Docket Item #13  
DEVELOPMENT SITE PLAN #2004-0018  
Beauregard / Armistead Towns

Planning Commission Meeting  
December 7, 2004

**ISSUE:** Consideration of a request for a development site plan, for construction of a 42-unit “townhouse-style” condominium development.

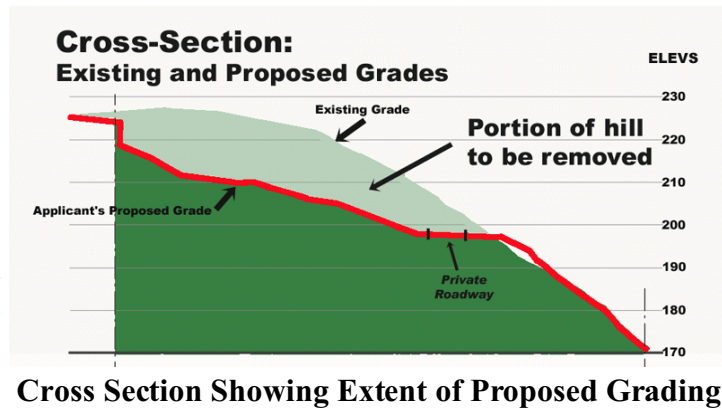
In order to attain compliance, staff is recommending eliminating four units (required in any event to comply with the RA zone’s open and usable space requirement) and shifting the remaining units 19 ft. farther from Beauregard to create a minimum 55 ft. setback and buffer from Beauregard Street. The applicant contends that there are other buildings as close to Beauregard as they are proposing. However, these buildings are generally lower scale buildings and are not elevated by the topography of the site as proposed by the applicant. In addition, most of the mature vegetation that would otherwise screen that building will be lost during construction. While most of the trees that are on the site are generally not large trees (6-24" caliper trees), collectively the trees create a dense tree canopy for the site and Beauregard. The development as proposed will eliminate much of this wooded area, as it requires the grading of approximately 85% of the property and will result in the loss of at least three-quarters of the trees that have a caliper size of 6" or greater. The degree of change from pre-development to post-development conditions is unnecessary to reasonable development of the site and will be dramatic. The adverse impact of an inadequate buffer will be exacerbated by the topography of this proposed development, as the buildings will be substantially elevated above the street grade.

Most of the required setbacks within the Zoning Ordinance include a setback ratio, which requires greater setbacks for taller buildings. This approach is also consistent with the recently completed Ashton Manor development, where the buildings have a setback ratio of greater than 2 to 1 and where the buildings are setback 72 to 88 ft. from the Beauregard roadway. Staff is recommending

that this application provide a setback that is closer to that which has been provided by recent developments in the corridor and will be consistent with the Open Space Plan, which lists Beauregard Street as a tree-lined boulevard which is to be protected and enhanced. This increased buffer, particularly at the intersection of Beauregard and Armistead Streets, will increase the number of trees that can be retained. These changes are the minimum buffer enhancements required to comply with Zoning Ordinance Sections 11-410(C), (F) and (W).
